Watercare Services Limited – Whenuapai Wastewater Servicing Scheme Package 1 – Regional consent – Further request for information response (Council reference: BUN60425801)

The following sets out our response to questions 1 and 4 of the request for further information (dated 11 April 2024), in relation to the Whenuapai Wastewater Scheme Package 1 Regional Resource Consent Application lodged by Watercare Services Limited for works in Whenuapai, Auckland.

Figure 1: imagery showing the proposed location of pump station, emergency overflow and pipelines. Alternative gravity main option suggested by Council Development Engineer is shown in purple.

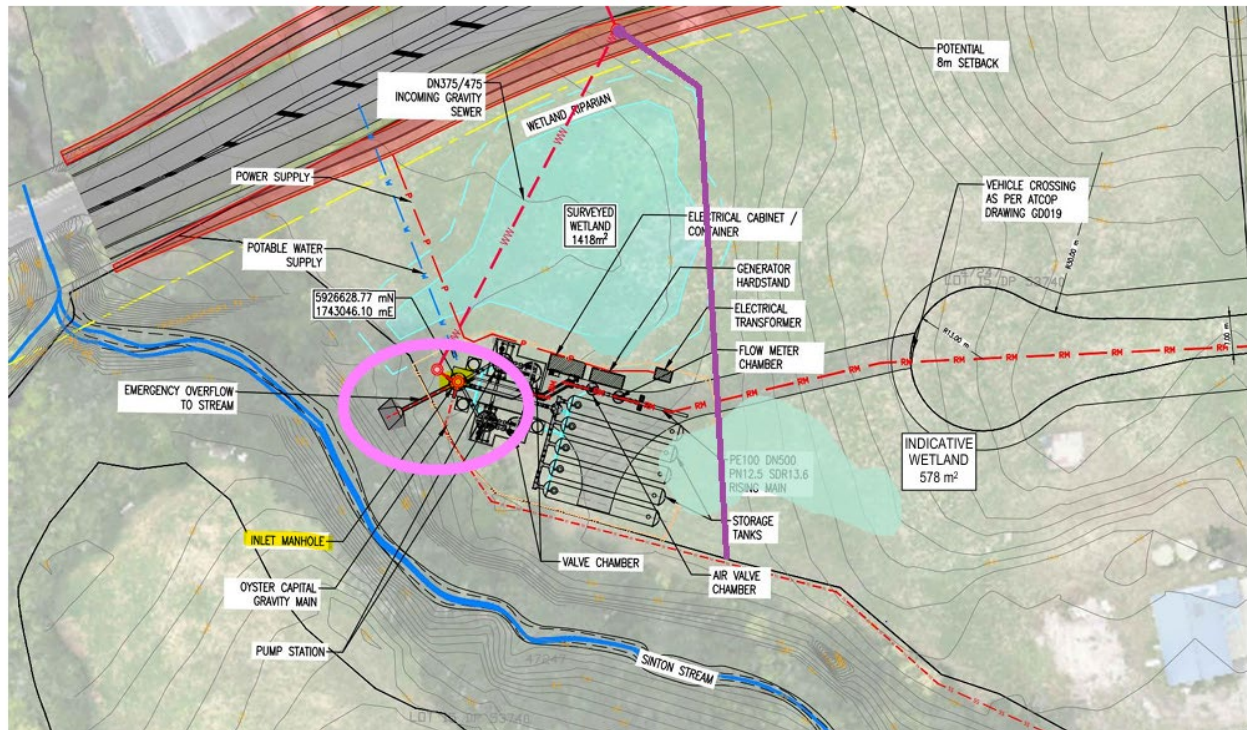
5. *Please provide further justifications/explanations on why works within and near the Wetland C and D are unavoidable. Please include pipe route, including consideration of rearranging structures within the WSL pump station land in this assessment.*

We disagreed with the Council Development Engineer’s opinion at a meeting on 14 June 2024 that there are other practical alternatives in avoiding impacts to wetlands. The suggested alternative of a straight gravity main by the east of Wetland C in attempt to reduce the number of diversion manholes would lead to substantial changes to the proposal without avoiding impact to wetlands.

The suggested alignment results in constructing the gravity main through Wetland D. It requires reconfiguring the inlet manhole and emergency overflow point to provide connection by the south of the pump station. Due to the higher ground and steeper slope in the area, the reconfigured outfall and riprap structures would be further set back from the stream, constraining the construction footprint available between the two wetlands. Based on site contours, the reconfiguration and longer gravity main would also require deeper excavations, which increase duration of works and groundwater drawdown of both Wetland C & D.

Therefore we maintain the view that all practical options have been explored in functional need assessment and there is no alternative that can avoid impact to the identified wetlands. It is necessary for the infrastructure to be located in this environment and Council should assess the resulting effects of the proposal on this basis.
